**NOTICE OF A REGULAR MEETING
BONDURANT PLANNING AND ZONING COMMISSION
MARCH 14, 2024**

TITLE: Resolution PZ-240208-05 - considering recommended approval of site plan for Alan's Seamless Gutters at 1601 Garfield Street SW

Alan's Seamless Gutters - Site Plan

SHEET 1

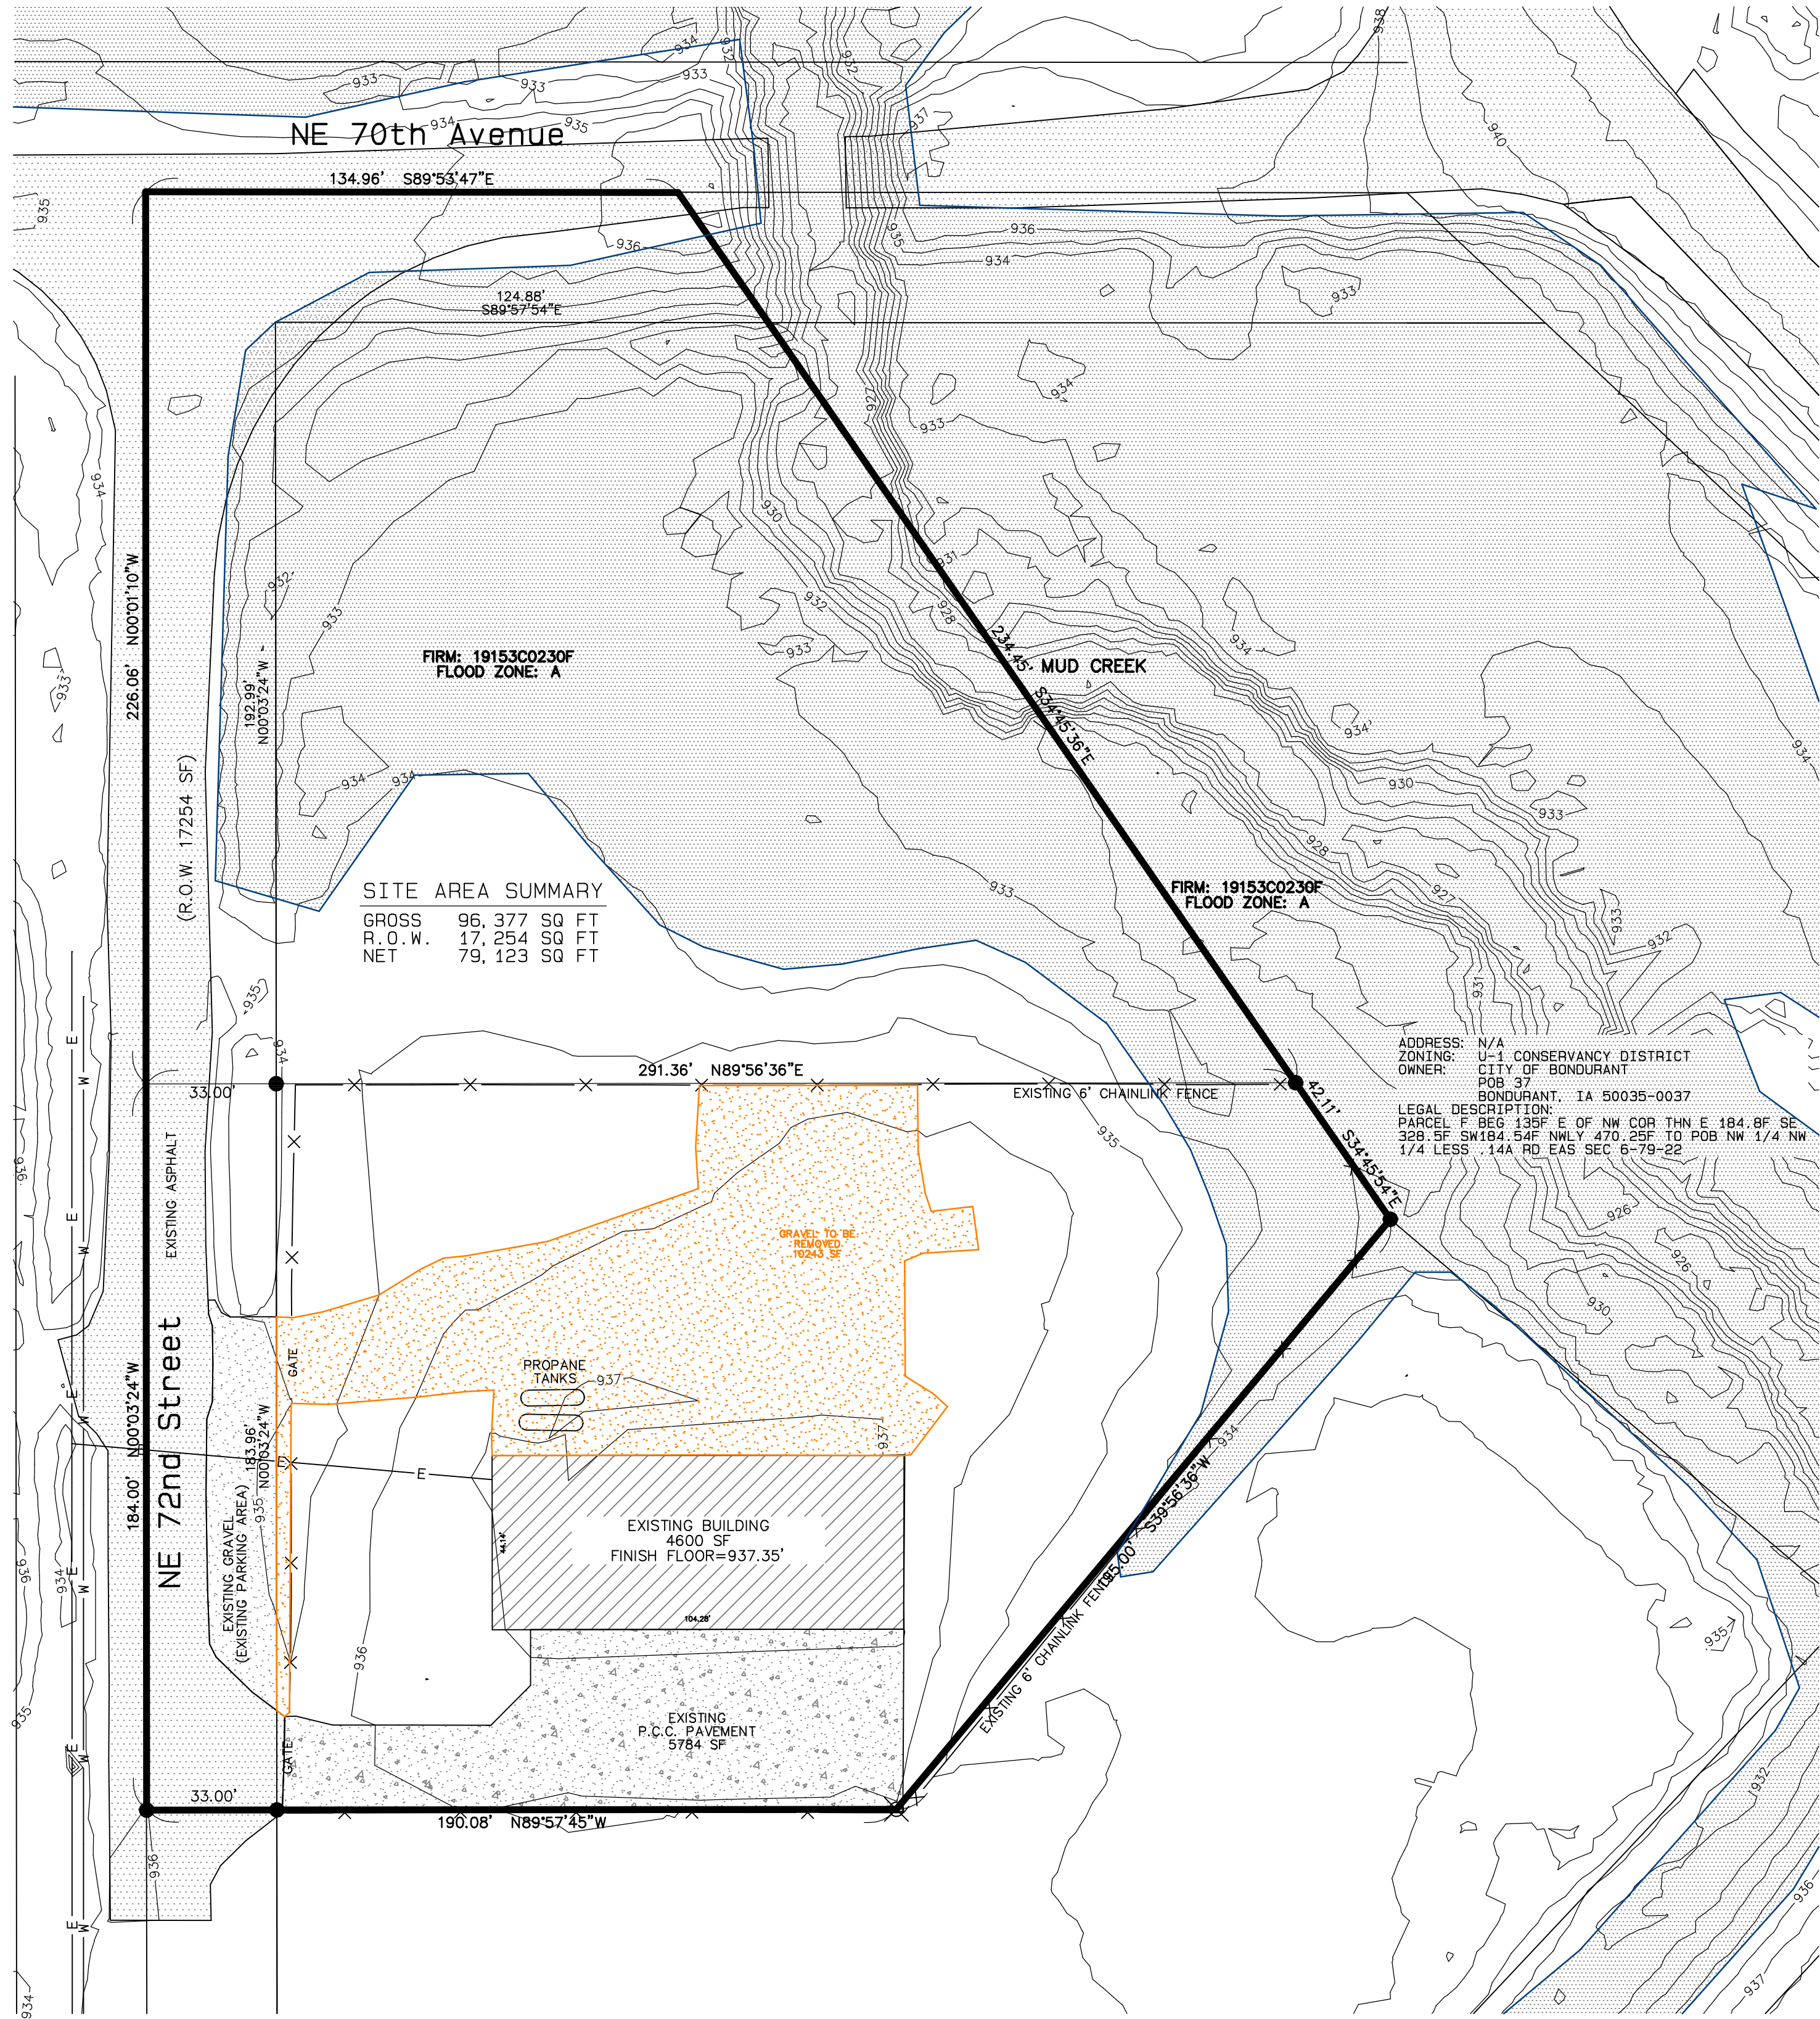
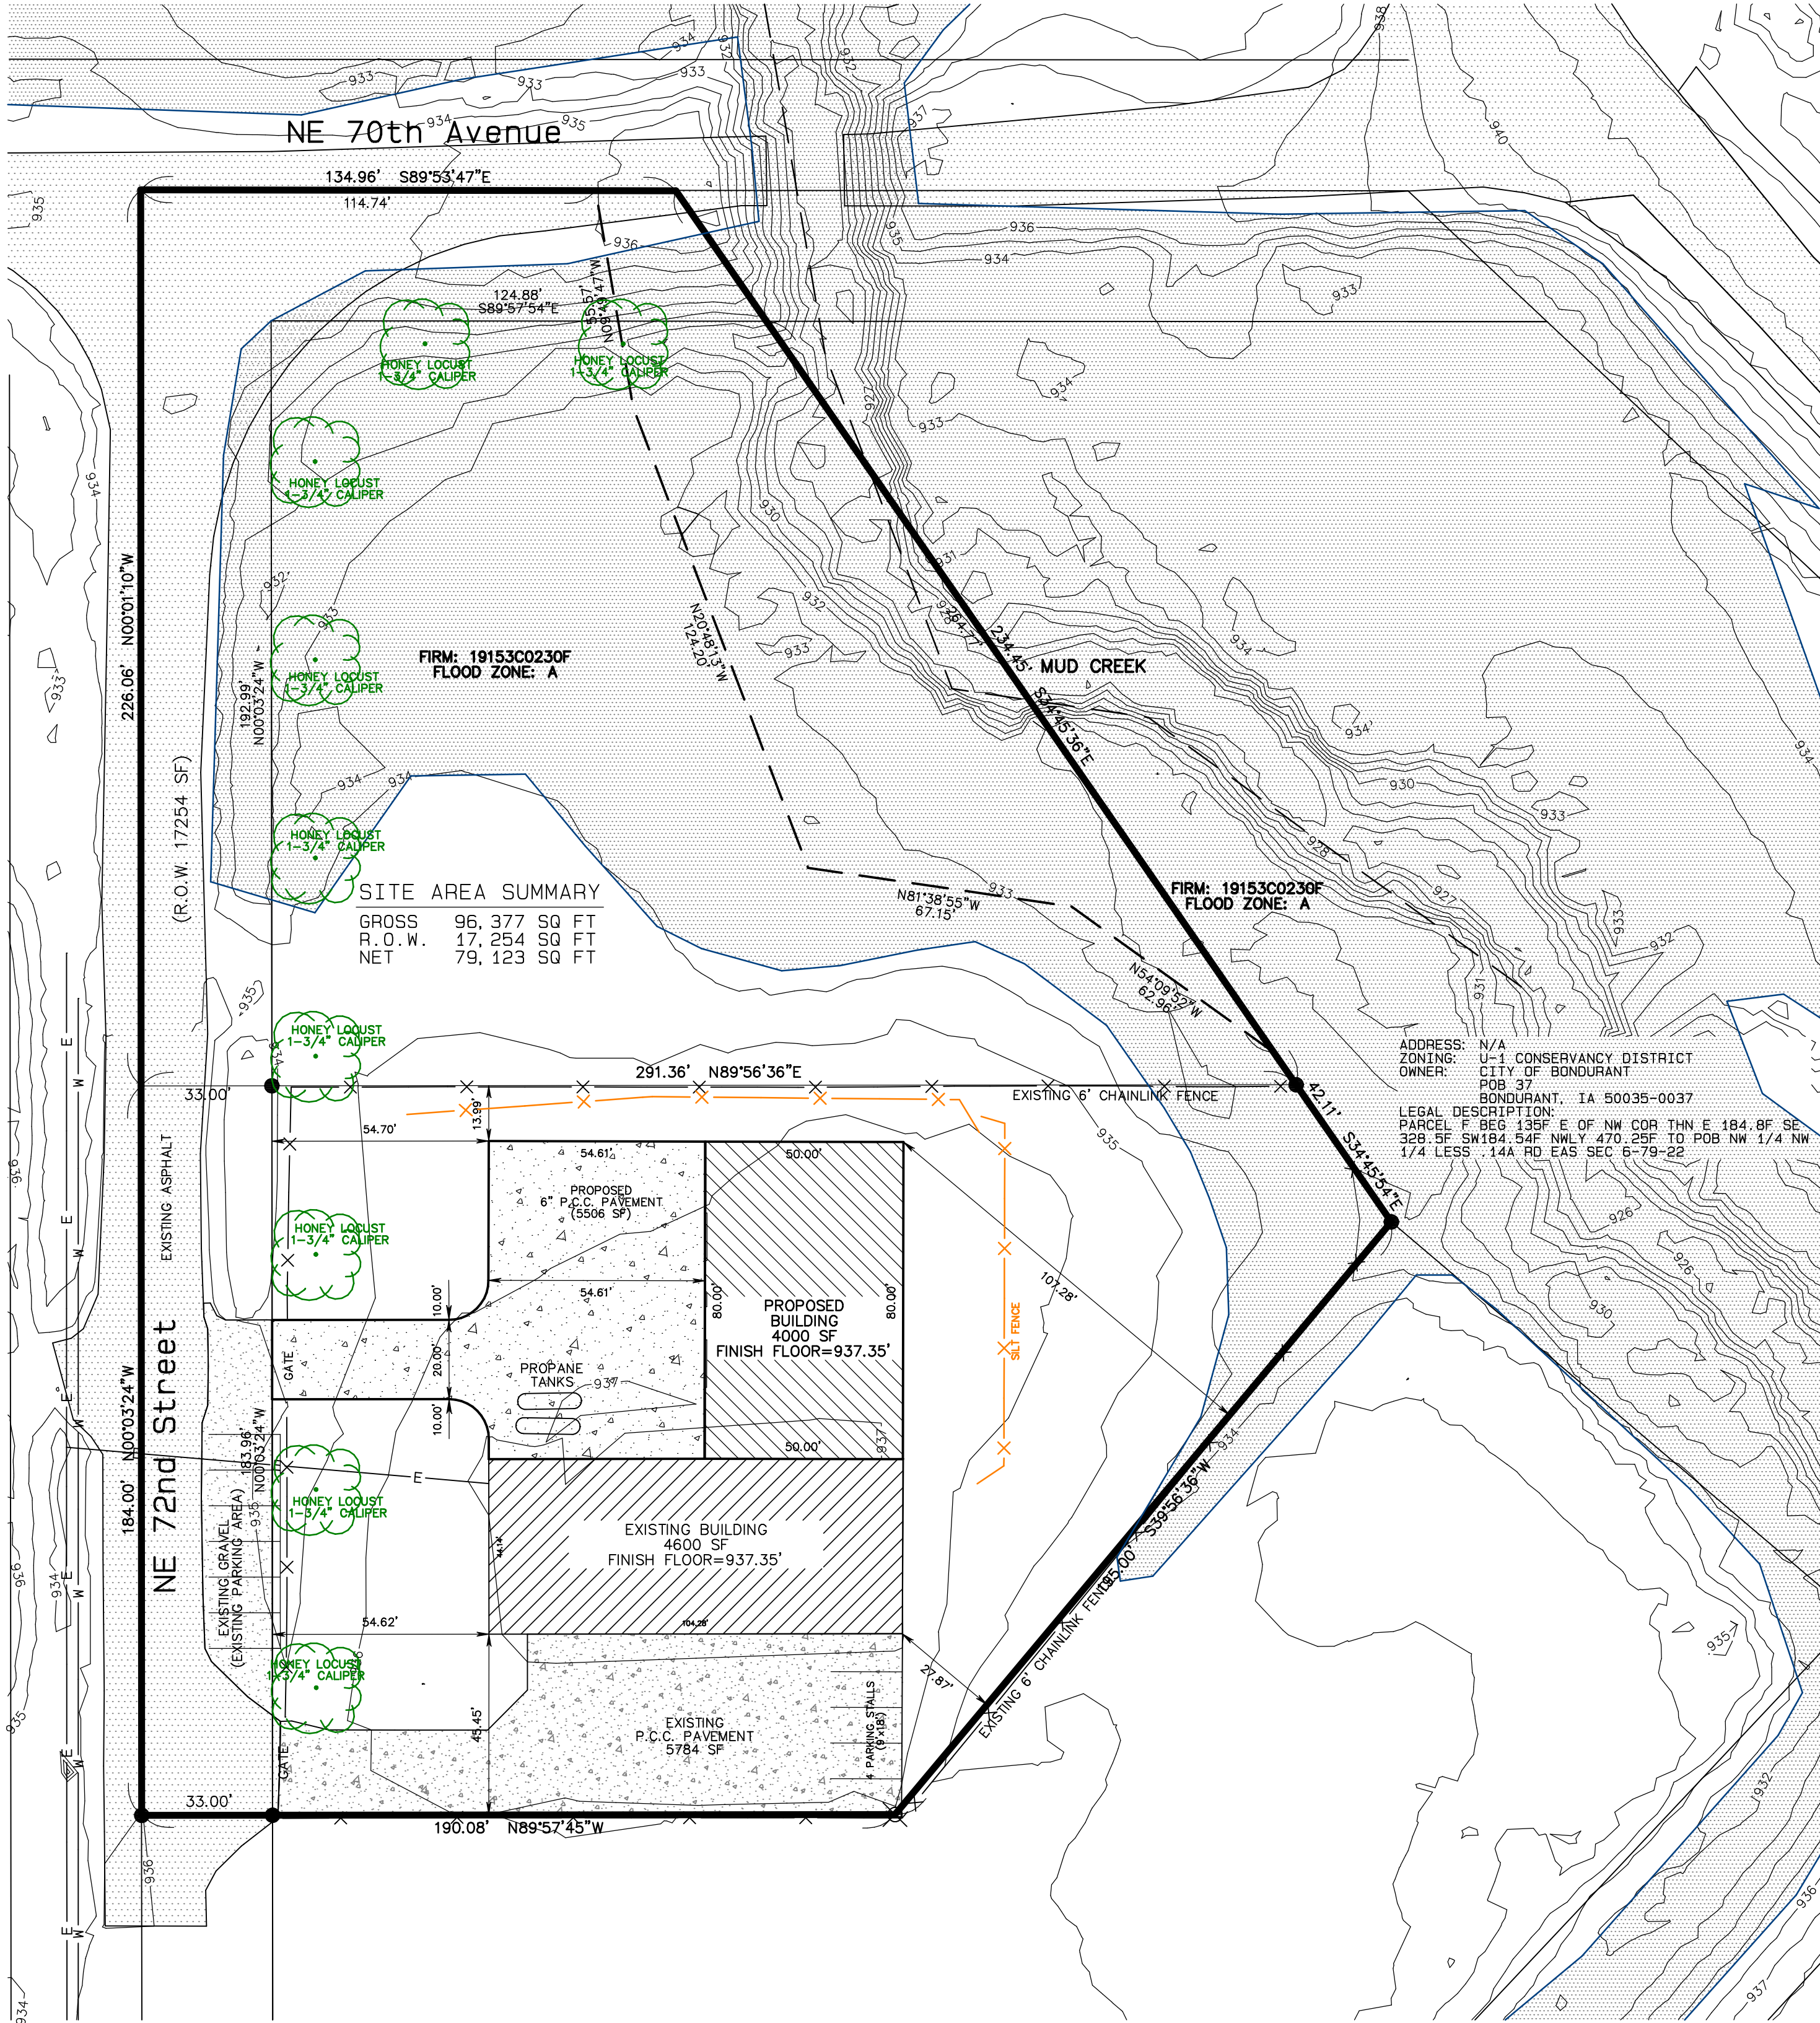
- The site plan labels the required setbacks at this location - a 50' front yard setback along Garfield Street SW, a 50' rear yard setback from their eastern property line and 20' side yard setbacks from the northern and southern property lines.

- Access to the site is available from Garfield Street SW. The site plan shows two existing access points in the southwest and northwest corners of the property. Both access drives are existing, and the access in the northwest corner would be used to access the proposed building.

- The site plan shows the existing access drive in the southeast corner of the site is closer than 10' from the southern property line. The additional access drive being used to access the proposed building will be more than 10' away from all property lines as required by Section 177.10.1.

- As previously noted, if the owner will be utilizing the existing gravel parking area adjacent to Garfield Street SW//NE 72nd Street, the site plan must be updated to show these areas as being paved; this has been factored into the attached resolution.

- Section 177.09.05 of the Zoning Code will be applied when determining minimum parking stall count requirements at this location. This section reads: Warehouse/Storage: one (1) space per employee. The site plan should be updated to include number of workers on site and number of parking stalls located on site. If this number is greater than five, then the applicant will need to show how they will meet this minimum parking stall count requirement (i.e. by paving a portion of the currently-gravel spaces along Garfield Street SW).

1. A copy of the recorded lot-tie agreement is submitted to the City.
2. Address comments from Veenstra & Kimm.
3. Site Plan shall be updated to include number of employees on site and number of parking stalls provided.
4. If proposing to utilize the existing gravel parking spaces along Garfield Street SW/NE 72nd Street, the site plan shall be updated to show this area will be paved.
5. Site Plan shall be updated to include stream buffer easement area that will need to be established.
